Integrated Precision Battery Sensor for Automotive System

Silicon Anomaly

ADuC7036

This anomaly list describes the known bugs, anomalies, and workarounds for the ADuC7036 integrated precision battery sensor. The anomalies listed apply to all ADuC7036 packaged material branded as follows:

Figure 1. Series Resistor and Decoupling Capacitor to Ground on VDD Pin

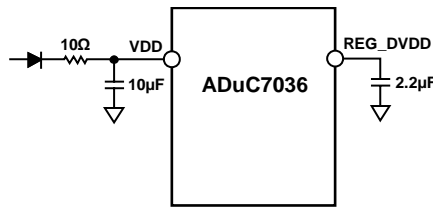
Issue: Under particular conditions, the POR does not release the reset signal (that is, the ASIC remains in reset) until a power cycle occurs. This POR error occurs only under three specific and coincident power-on conditions:

- Fast ramp on VDD, nominally faster than 100 μ s from initial value of VDD (V_{INIT}) to 12 V.
- $V_{INIT} = \sim 1.2$ V.
- Voltage on REG_DVDD at the time VDD ramp is reapplied = ~ 175 mV.

Workaround: A fast VDD ramp (that is, ramping from ~ 1.2 V to 12 V in less than 100 μ s) is required as one of the conditions to initiate the reported POR issue. Analog Devices recommends careful selection of external power supply decoupling components to ensure that the VDD supply ramp rate can always be guaranteed to be greater than 100 μ s under all VBAT power-on conditions. Specifically, Analog Devices recommends using a 10 Ω series resistor (1% tolerance maximum) and a 10 μ F decoupling capacitor (20% tolerance maximum) to ground on the VDD line between the reverse protection diode and VDD, as shown in Figure 1.
